MYSO, LLC  
Response to Siting Board Staff's Second Request for Information  
Case No. 2025-00395

Request No. 1:

- Project Boundary
- Project Fence Line
- Substation
- 2,000 Foot Buffer
- Inverter Skid
- Residence
- ⊕ Masonic Lodge
- ⊕ Cemetery
- ⊕ Fire Station
- ★ Church
- △ Boundary Receptor (Loudest Boundary Point)

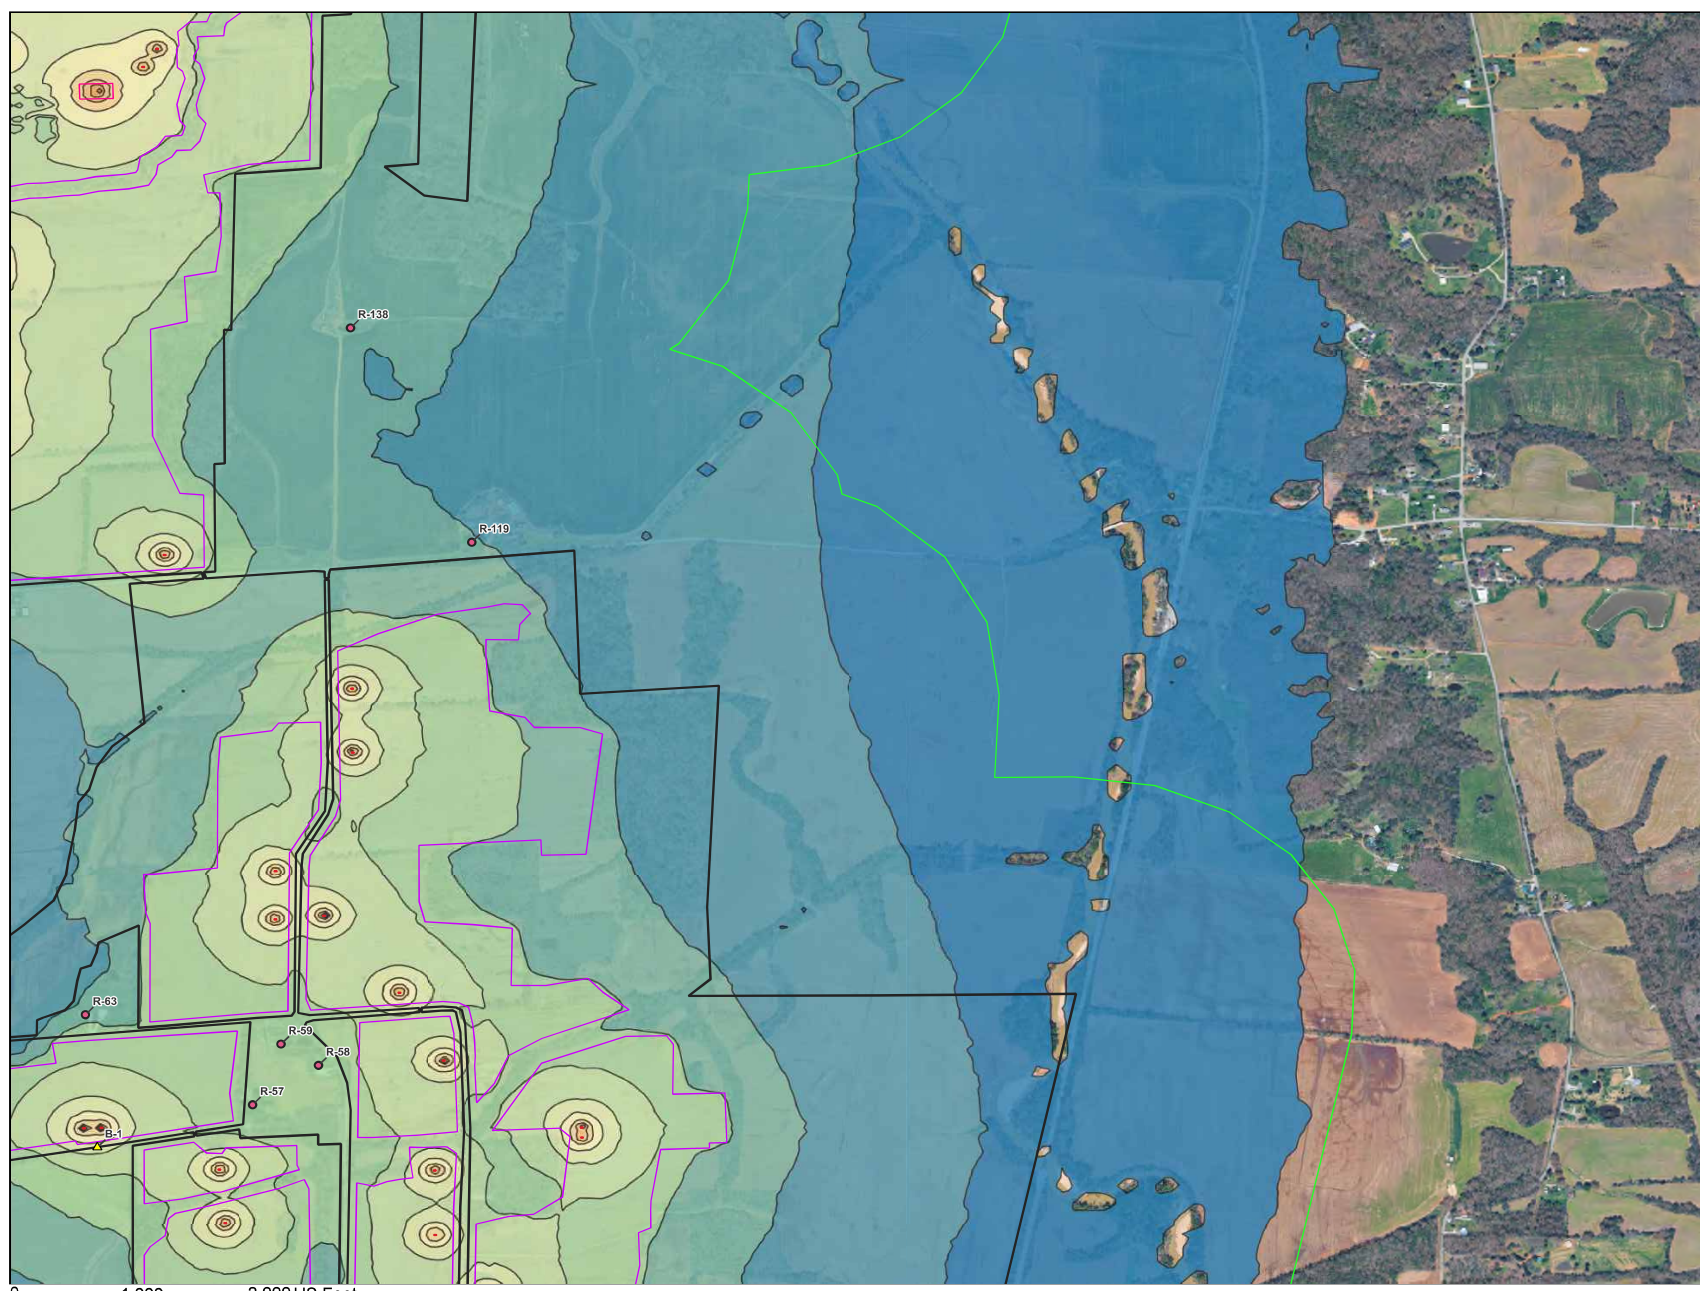
Refer to Application, SAR, Attachment D, Acoustic Analysis. Provide updated Figure-1 maps that reflect the revised list of Residential Structures from MYSO's response to Staff's First Request, Item 7. Include the following receptors on the updated maps that are not included in the "Residential Structures Within 2,000 Feet" Table: R-166, the omitted residence located at 5601 KY-1204, CH-1, CH-2, F-1, M-1, and C-1.

Please see the map set attached hereto and the tables attached to Response Nos. 3 and 40. The referenced maps set and tables have been updated to include receptor R-166 and the omitted residence located at 5601 KY-1204, identified as R-184.

## Potential Visibility Points

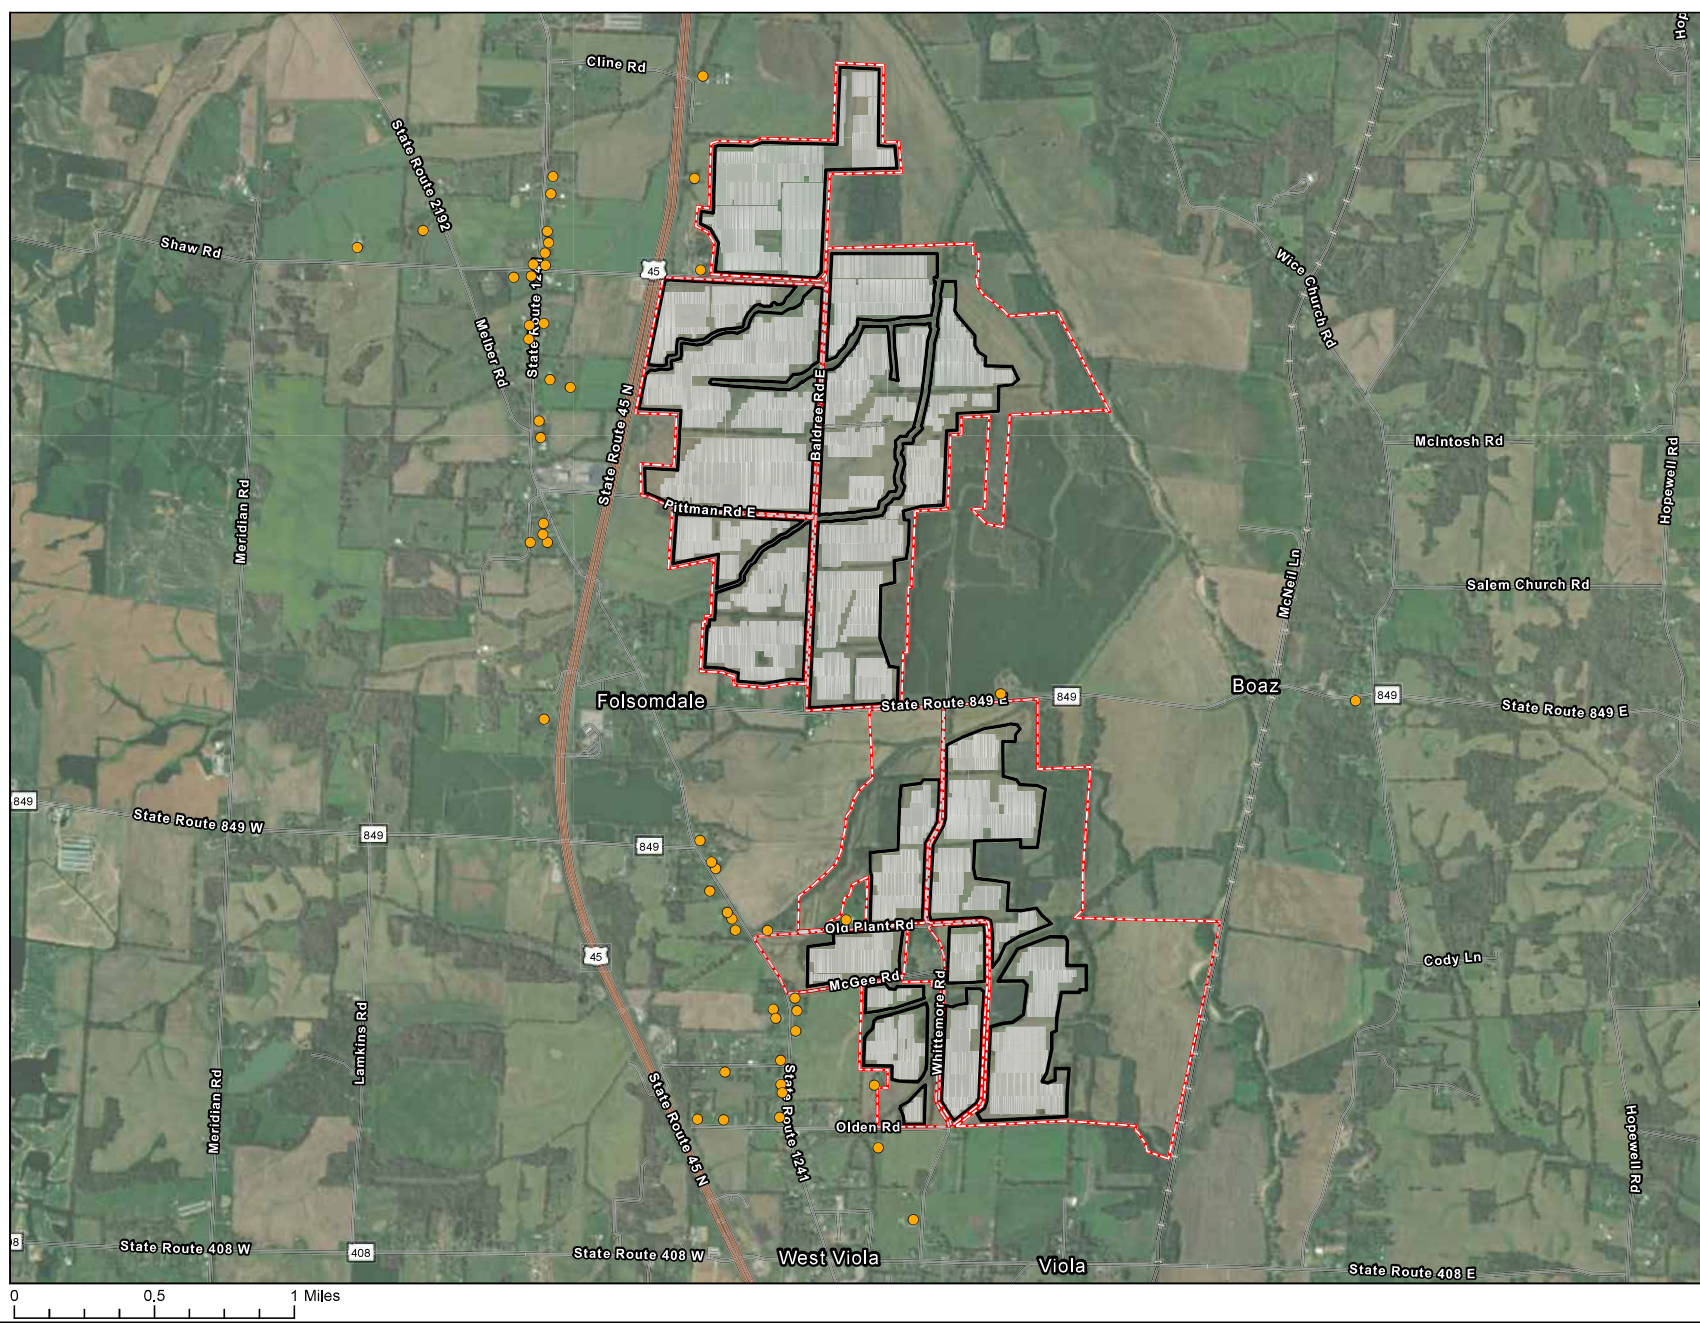
Refer to MYSO's response to Staff's First Request, Item 88. Identify approximately the 60 to 80 residences that may have a limited view of some portion of the Project on a map.

DATE	REV.	REVISION HISTORY	DRN. BY	CKD. BY	APPD. BY
2026-05-04	00	FIRST ISSUE	SP	MA	KP
		BrightNight Power			
PROJECT NAME		MAYFIELD SOLAR			
DRAWING TITLE		PLANT LAYOUT (PVS)			
SCALE	PURPOSE CODE	SHEET SIZE	REV.	SHEET	
1" = 900'	ISSUE FOR PERMIT	36" x 24"	00	2 OF 2

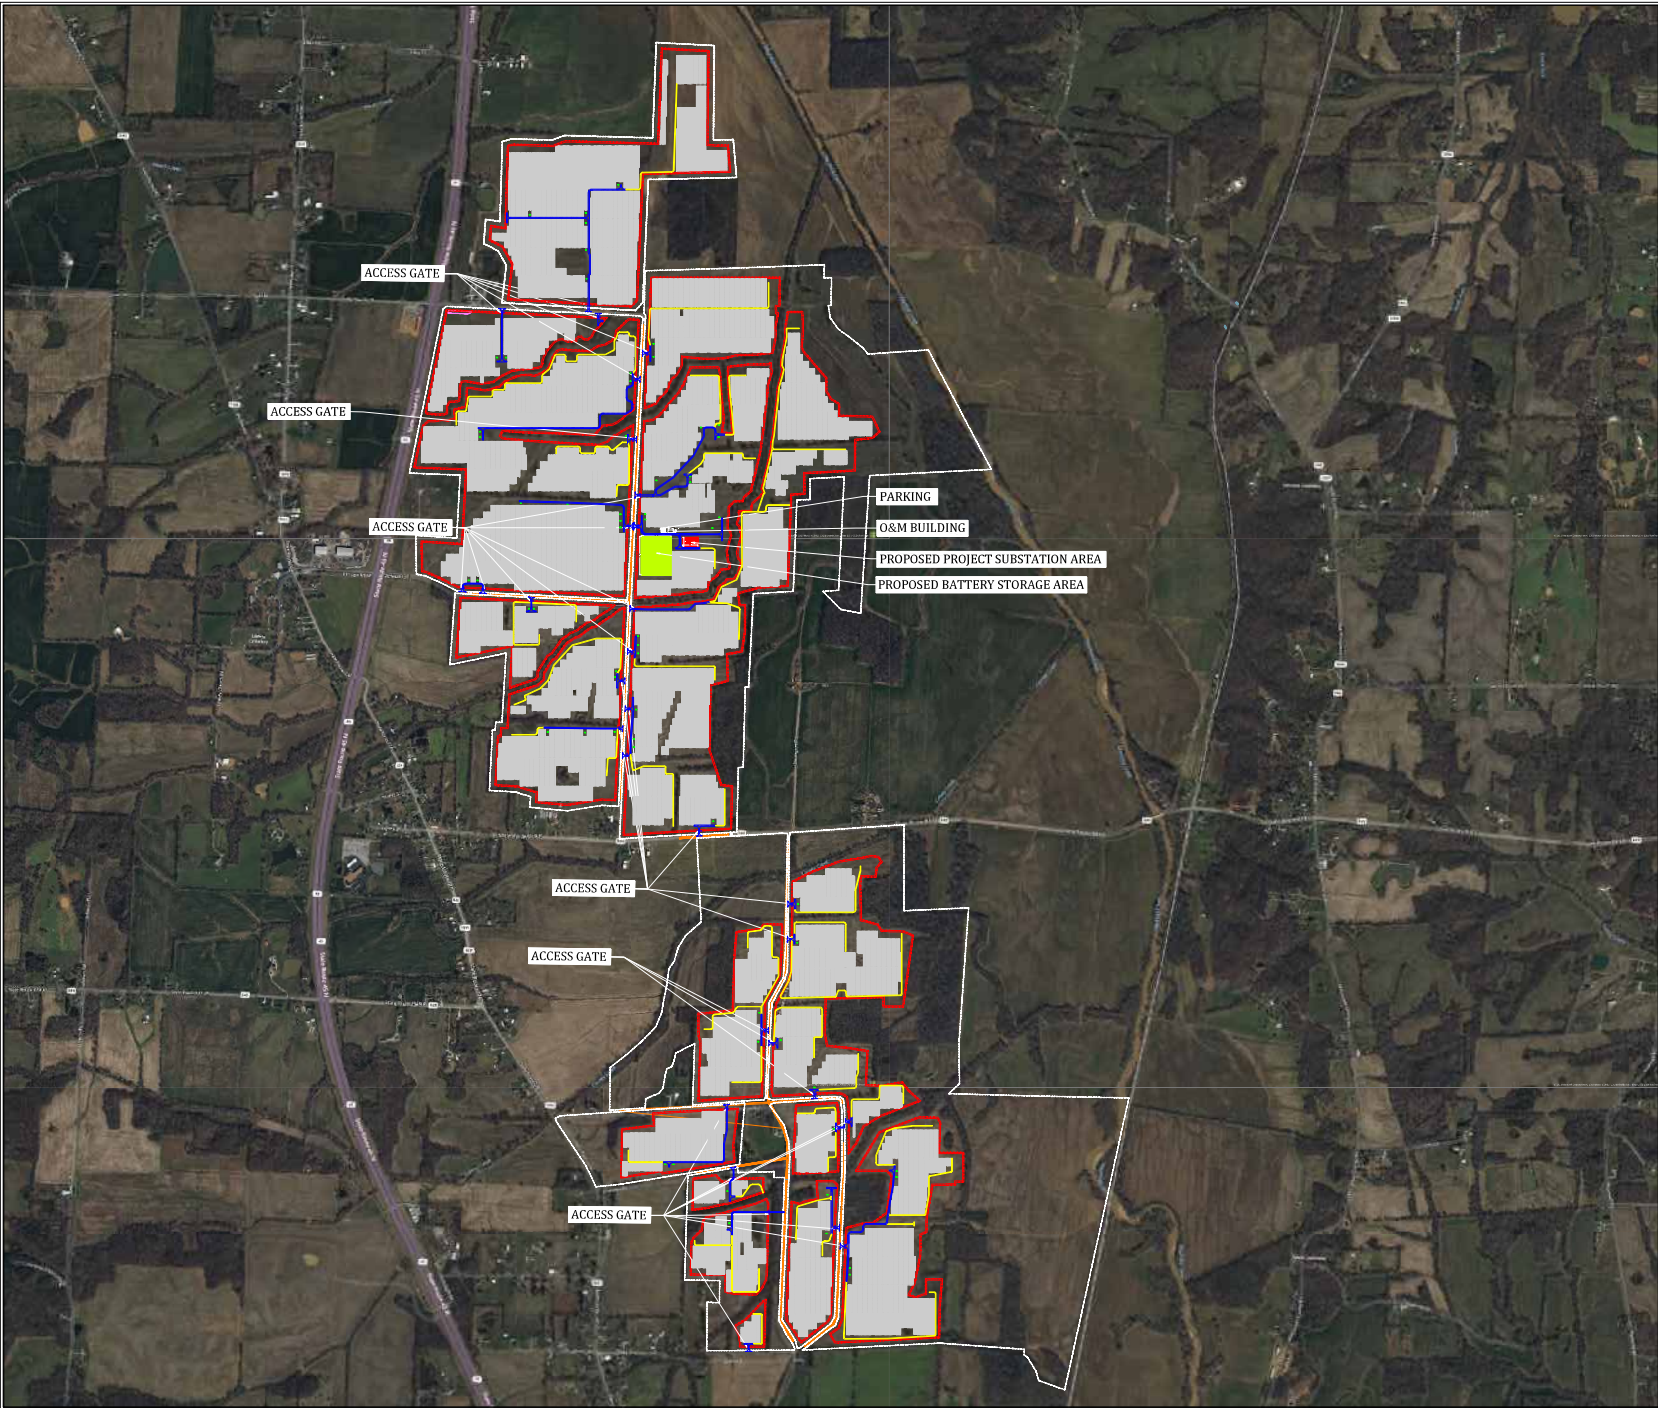
Refer to the Application, Amended Exhibit I, Decommissioning Plan. Provide a revised Site Layout map showing the locations and lengths of the 10-foot-wide basin access roads.

The basin access roads referenced in the Decommissioning Plan are illustrated in SAR Attachment A, as part of the "access roads" noted throughout the Project. To the extent the differentiation of roads assists with review, see attached; however, final locations of basin access roads will be decided by the Project's EPC contractor.
